Access Compliance Report

Public Rights-of-Way

Intersection ID: N/A	Main Street: SPEER_BV	Cross Street: NATIONAL_AV	Location: SW
ADA ID: 39C819EEB9C1	Ramp Type: MedianPerp	Initial Pass/Fail: Pass	Overall Compliance: No
		Severity Score: 2.5

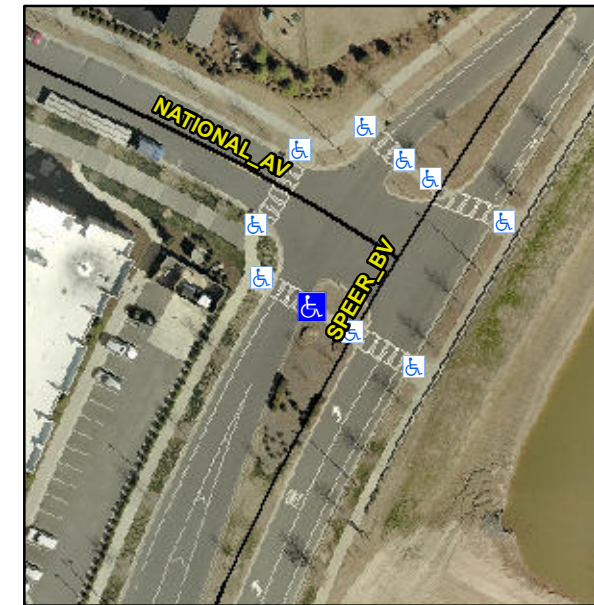
R304.2.3

Compliance	Description	Data	Compliance	Description	Data
N/A	Ramp Length (in)	59.0	Yes	Ramp Slope (%)	5.3
Yes	Ramp Width (in)	72.0	Yes	Ramp XSlope (%)	1.9
N/A	Flare Type LT	Sloped	N/A	Flare Type RT	N/A
N/A	Flare Slope LT (%)	11.0	Yes	Flare Slope RT (%)	8.6
N/A	Flare Traversable LT?	Yes	N/A	Flare Traversable RT?	Yes
Yes	Landing Length (in)	60.0	Yes	DWS Provided?	Yes
Yes	Landing Width (in)	72.0	Yes	DWS Contrast?	Yes
Yes	Landing Slope (%)	0.9	Yes	DWS Length (in)	24.0
Yes	Landing X Slope (%)	0.4	Yes	DWS Full Width?	Yes
N/A	Landing Curb? (Y/N)	N/A	Yes	DWS Offset (in)	0.0
N/A	Shared Landing?	No			
Yes	Gutter Ponding?	No	Yes	Gutter Slope (%)	0.9
Yes	Gutter Lip Ht (in)	0.0	Yes	Gutter X Slope (%)	0.5
N/A	Painted X Walk1?	Yes	N/A	Painted X Walk2?	N/A
	X Walk 1 Direction	To NW		X Walk 2 Direction	N/A
N/A	X Walk 1 Width (in)	112.0	N/A	X Walk 2 Width (in)	N/A
	X Walk 1 Slope (%)	3.9		X Walk 2 Slope (%)	N/A
	X Walk 1 X Slope (%)	0.8		X Walk 2 X Slope (%)	N/A

Remove & Replace Flare.
